SUBJECT: AWS Structural Welding Code

Supplemental Specification 807-1 has been revised effective April 27, 1989, to designate the Bridge Welding Code ANSI/AASHTO/AWS D1.5-88 as to the Governing Specification for welded highway structures. This makes the new welding code in effect for the May 31, 1989, and later lettings.

ACCEPTABLE BUTT WELDS

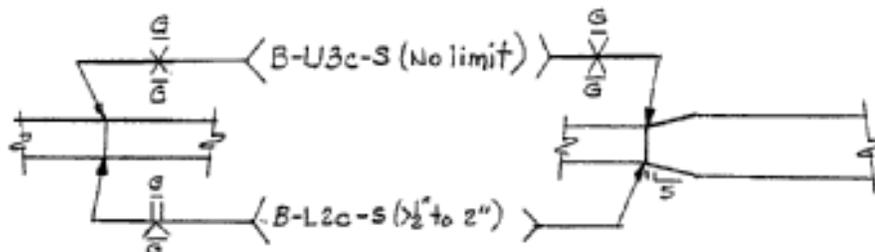
Due to change in the acceptable welds in the new code, our previous list of acceptable butt welds has been revised. Attached is a copy of the revised sheet.
